ITEM #2 - PRELIMINARY PLAT FIREWEED MEADOWS 2024

KPB File No.	2024-092	
Plat Committee Meeting:	g: October 14, 2024	
Applicant / Owner: Emmitt & Mary Trimble Joint Revocable Trust As Owners of ENM, LLC		
	Home Grown Construction, LLC	
Surveyor:	Stephen Smith / Geovera, LLC	
General Location:	Milo Fritz Ave, Anchor Point Area / Anchor Point APC

STAFF REPORT

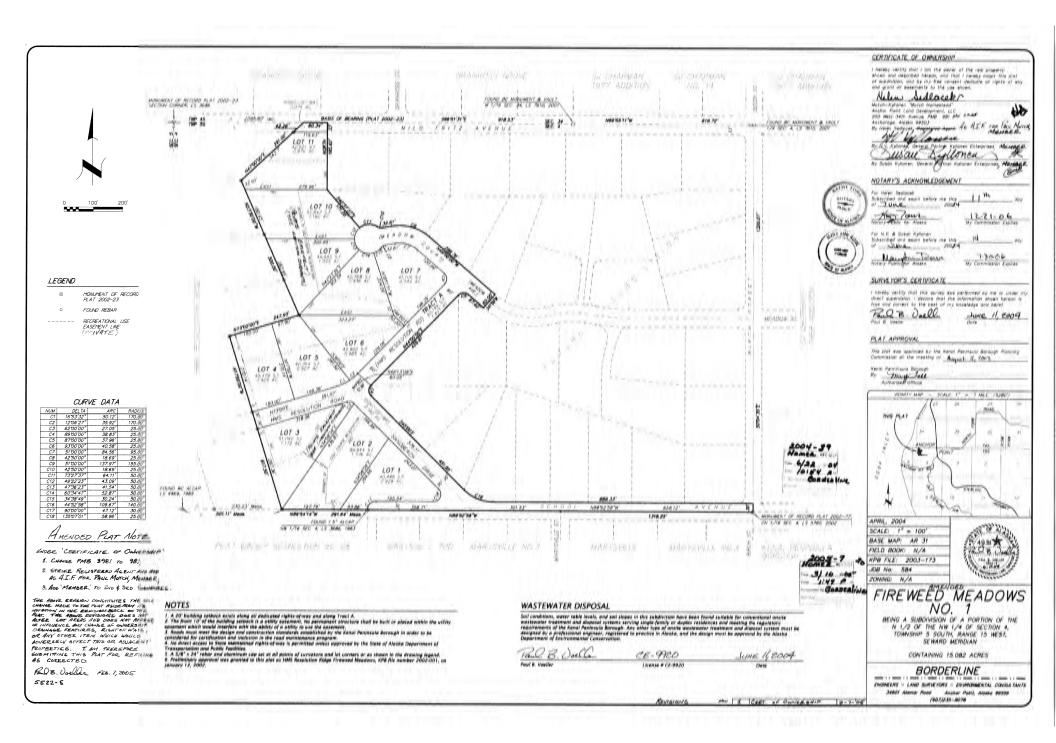
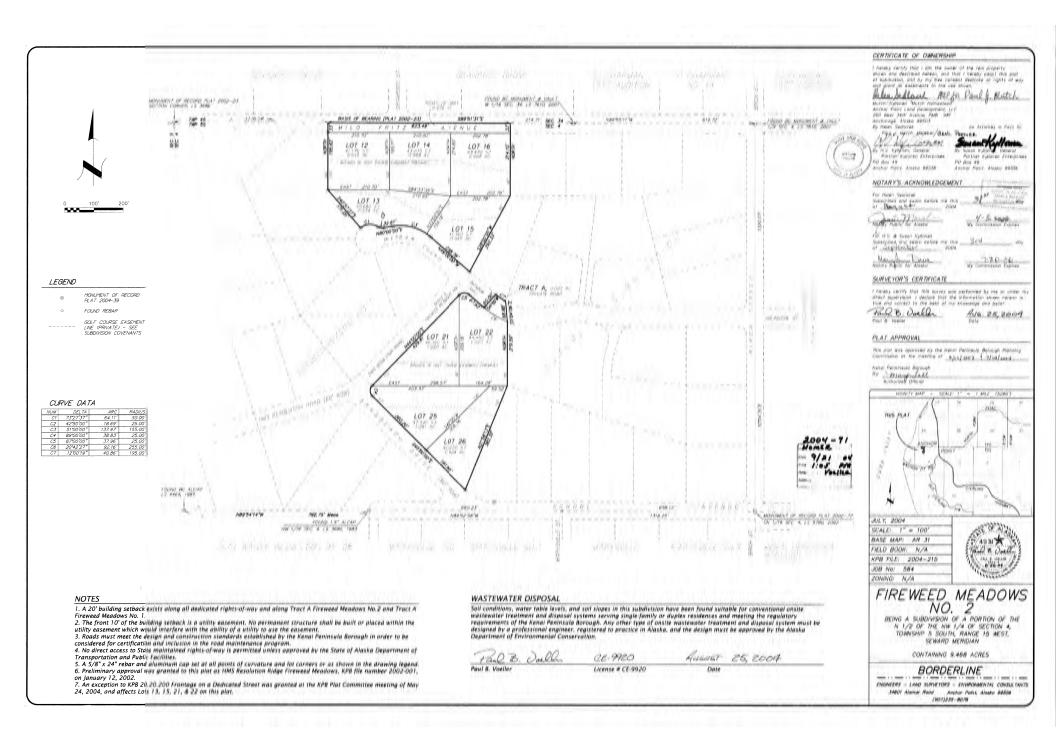
Several plat notes have typographical errors that need correcting, please review and correct. Specifically noted in #8 and 12, please look for others.

Plat note #7 should be revised, as 2005-001345-0 states that is cancels and supersedes the previous documents listed.

Label in southwest L14 /{L15} should be a matching label for the same line, both be either 14 or 15. Add to the Certificate of Acceptance "Chip Shot Ct"

Revise KPB File no to 2024-092

Correct the address for ENM, LLC to PO Box 150 per KPB Assessing information

Show the intersection of Birch Street to the north correctly, with s slight offset.

Show the full with of Birch St to the south and correct the with label.

Add the name of HMS Resolution Road to the southwest.

Show the 33' section line easements along the north line of the subdivision and east and west.

Add Birch St to the vicinity map.

Add Chip Shot Ct to the Certificate of Acceptance

Add a plat note about the intended use and ownership of proposed Tract A.

He notes for the previous Tracts A's being vacated can be removed, as they were private road parcels not public dedications, so not vacation is required.

Parcels to the southeast need to have the lot labels corrected as a new plat has been filed for the deed parcel.

Lot 1-A to the south is in process of being resubdivided, please check status before recording plat. To the east the flag lots between Lot 22-a and 23-C, need lot labels added

Relabel Tract A to Tract B or Tract A-1
